Agenda Item # 27

SUB-003760-2026 & SUB-SW-003756-2026

Hackbarth Gardens Subdivision

- Subdivision approval to create one (1) legal lot of record.
- Waive construction of sidewalks along Riviere Du Chien Road.

SITE PLAN

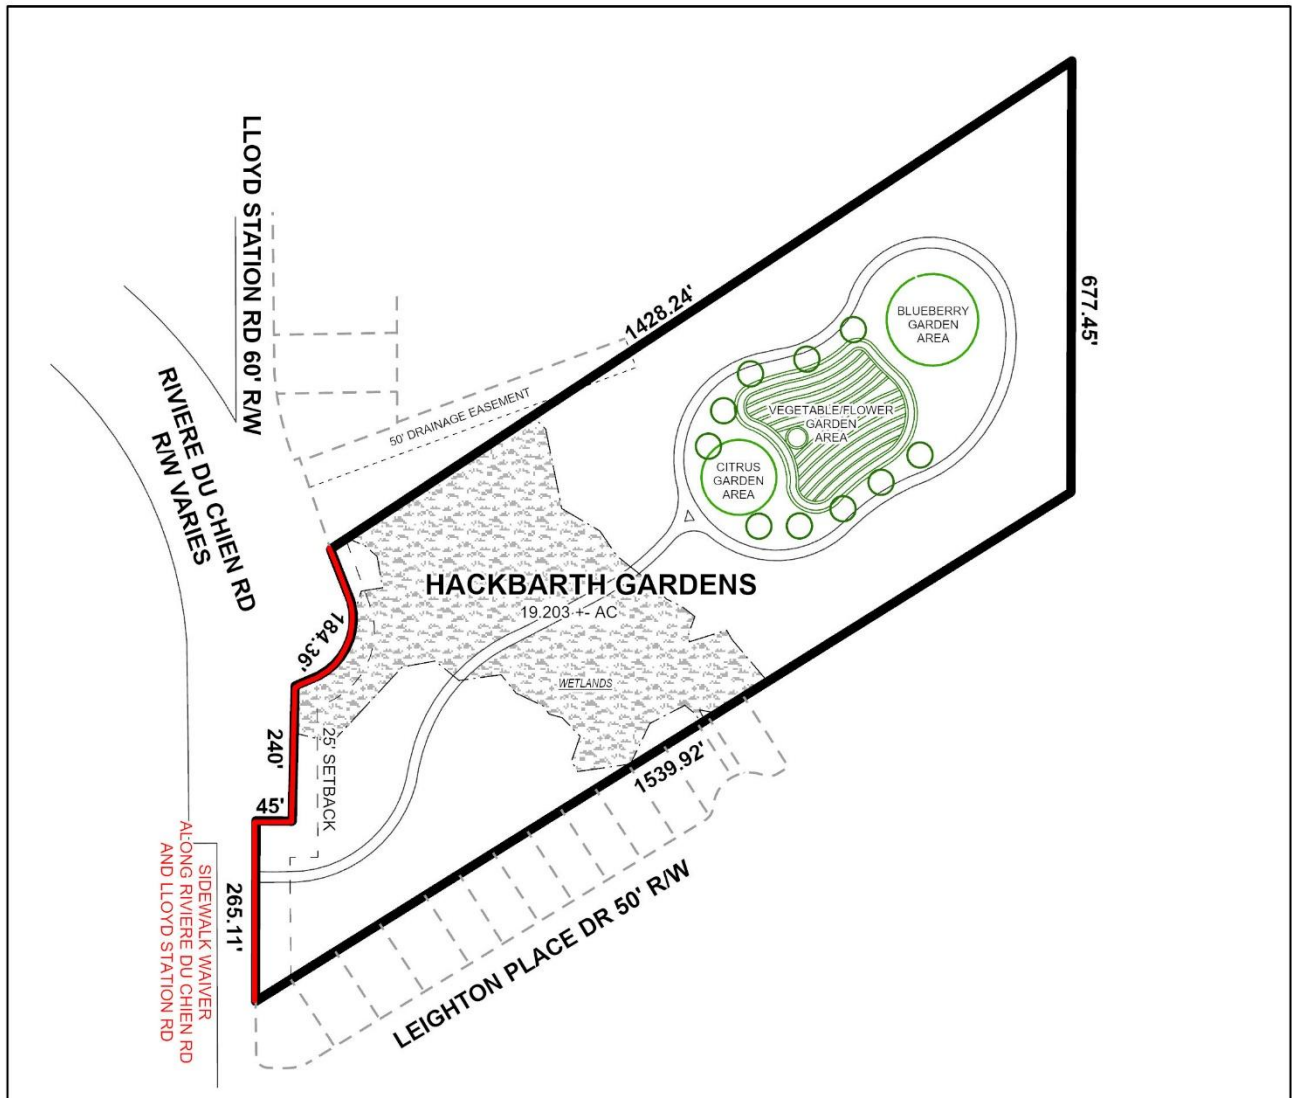
The preliminary plat clearly identifies the proposed lot lines; however, the new lot is not labeled “Lot 1” or a similar designation. If approved, the resulting lot should be labeled “Lot 1” on the Final Plat.

The site has frontage on Riviere Du Chein Road and Lloyd Station Road, both minor streets without curb and gutter. The preliminary plat indicates that Lloyd Station Road has an existing compliant 60-foot-wide right-of-way. Riviere Du Chein Road is depicted as having a varying right-of-way. As such, if approved, either dedication should be made to provide 30 feet from the centerline of Riviere Du Chein Road or the plat should depict that such right-of-way currently exists.

The preliminary plat illustrates the required 25-foot minimum front yard setback along the entire frontage. If approved, these setback lines should be retained on the Final Plat. The preliminary plat also includes a note about side yard setbacks that are incorrect, as they pre-date the UDC. If approved, the note referencing side and rear setbacks should be removed from the Final Plat.

The preliminary plat indicates the proposed lot size in both square feet and acres. If approved, this information should be retained on the Final Plat, adjusted for any dedication required.

The preliminary plat depicts a portion of a 50-foot drainage easement within the proposed Subdivision. If approved, a note should be placed on the Final Plat stating that no structure shall be constructed or placed within any easement without permission of the easement holder.

The applicant requests a waiver of the requirement to construct a sidewalk along the Riviere Du Chein Road. There are no existing sidewalks in the area along either Riviere Du Chein Road or Lloyd Station Road.

In support of the waiver request, the applicant states that this is a rural residential area, with no connecting sidewalks. Furthermore, the applicant states that a turning lane onto Lloyd Station Road along the frontage would create unsafe pedestrian walking conditions. No cross-sections of the topography were provided to illustrate that a sidewalk would be undesirable.

Engineering staff have indicated that sufficient space appears to exist either within the right-of-way or on the subject property to accommodate a sidewalk, which could be permitted through the right-of-way permit process.

1. Retention of the 60-foot-wide right-of-way along Lloyd Station Road on the Final Plat;
2. Either dedication to provide 30 feet to the centerline along Riviere Du Chein Road or illustration that such right-of-way currently exists;

3. Label the new lot as "Lot 1";
4. Retention of the lot size in square feet and acres, or provision of a table on the Final Plat with the same information, adjusted for dedication;

5. Revision of the Final Plat to remove the side and rear yard setback notes;
6. Retention of the 25-foot minimum front yard setback line along the entire frontage;

7. Placement of a note on the Final Plat stating that no structure shall be constructed or placed in any easement without permission from the easement holder;
